First Technology Safety Systems

Proposed Flex PLI GTR Updates

Mark Burleigh, Bernard Been
FTSS Europe
May 14, 2009

Bone PCB potting replaced with shrink wrap

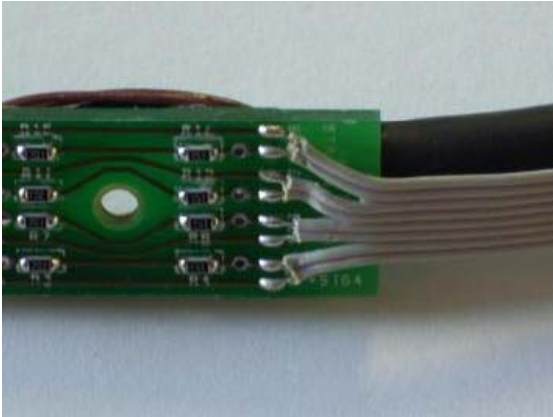
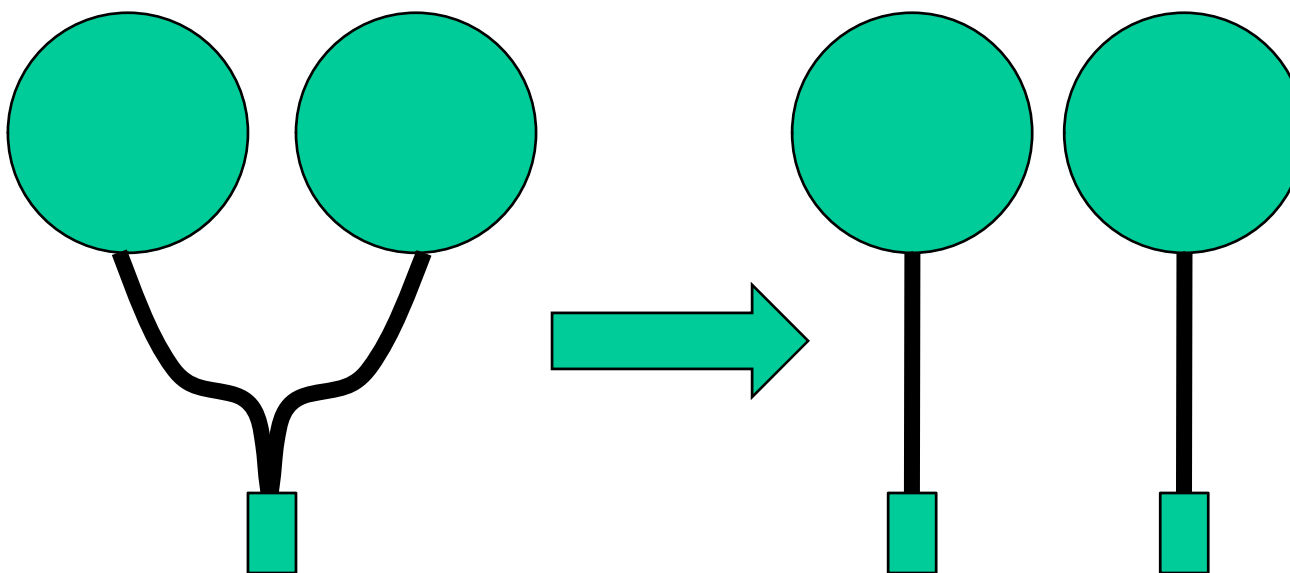
- Wire failures occurred in production process due to thin fragile gage wires
- Quality of molding was a problem (air pockets)
- This lead to scrap and rework
- New unit has lower profile
- PCB can now be repaired if there is a problem
- High strength Double sided tape still used to fit to bone
- Protective cover to gages still used

Flexible ribbon gage wires more durable

Heat shrink cover with tie wrap retention

String potentiometer crimp test

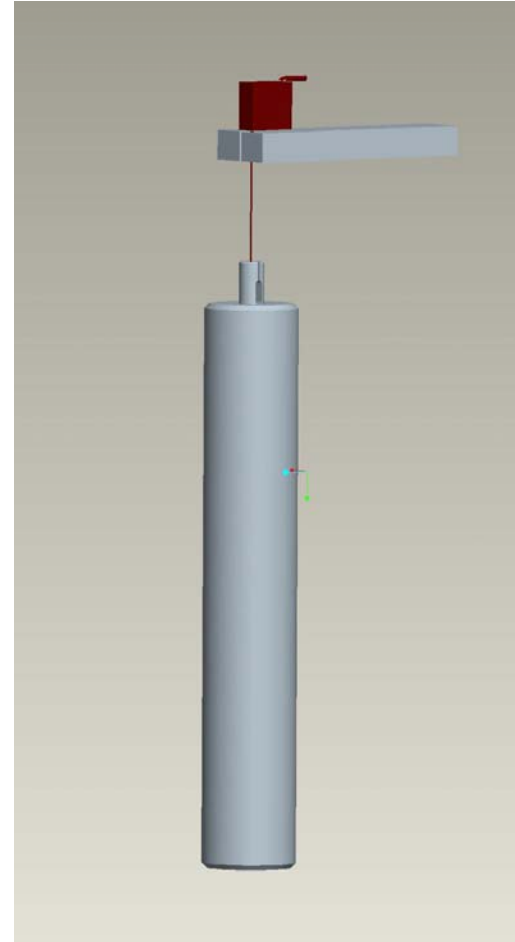
Wire crimp is loaded to 20 N to
Ensure crimp strength can
withstand expected maximum
loading

Proposed removal of connector blocks

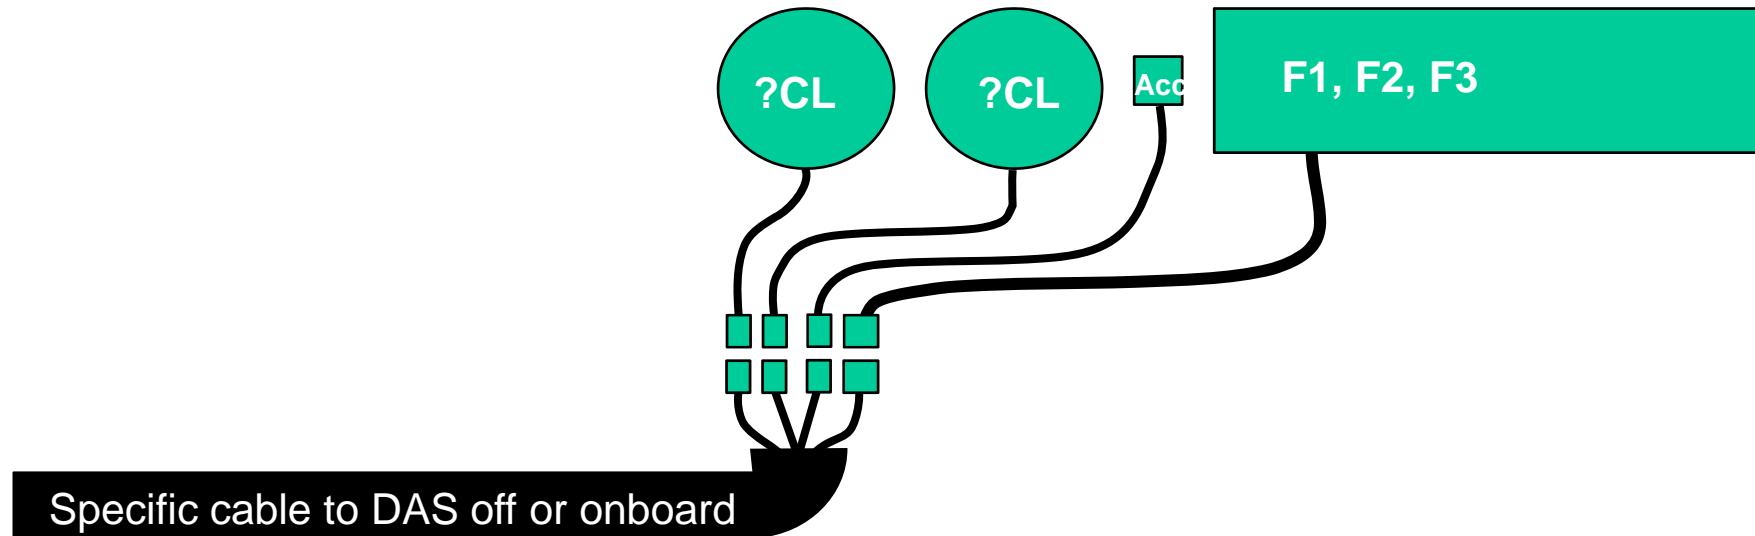
- Off board cable and DAS connect directly to sensors
- Removal of block provides space for 24ch on board DAS
- Propose use of Omnetic connectors with locking latch 7 and 16 pin. ID chips fitted
- Can remove disadvantages of Nano D connectors
 - Nano D connectors are non serviceable
 - Nano D connectors and block are expensive
 - Nano D connectors have long lead time

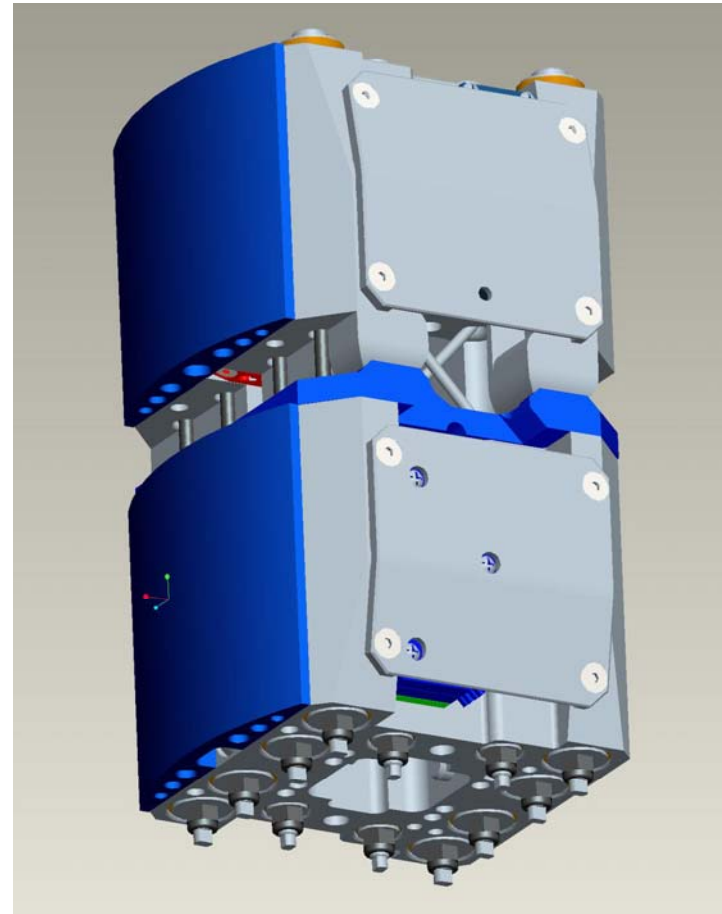
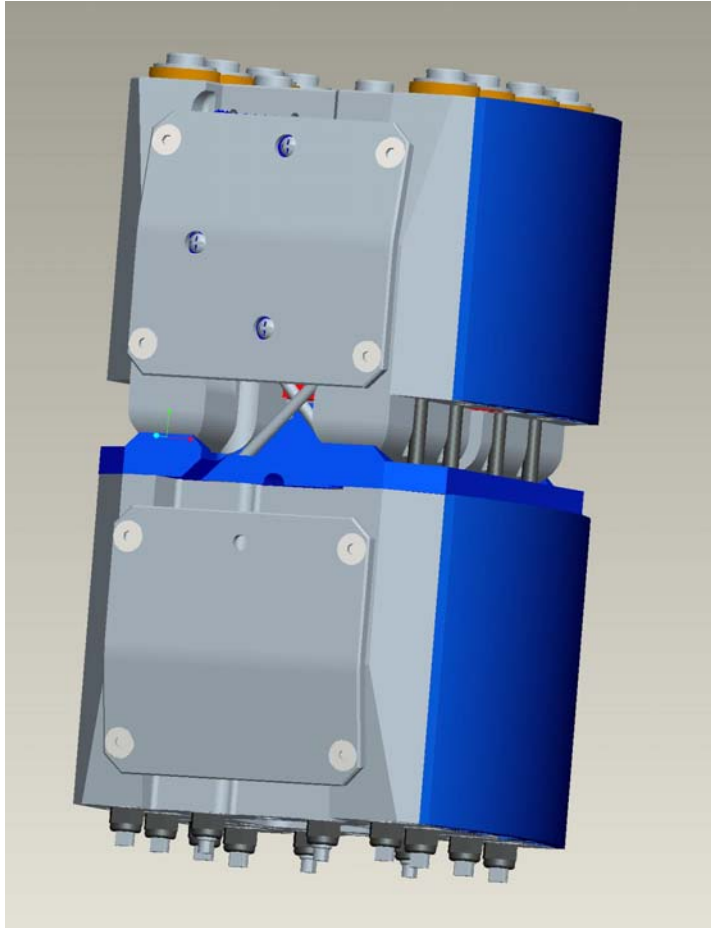
Holes added to side covers to clear SLICE screws
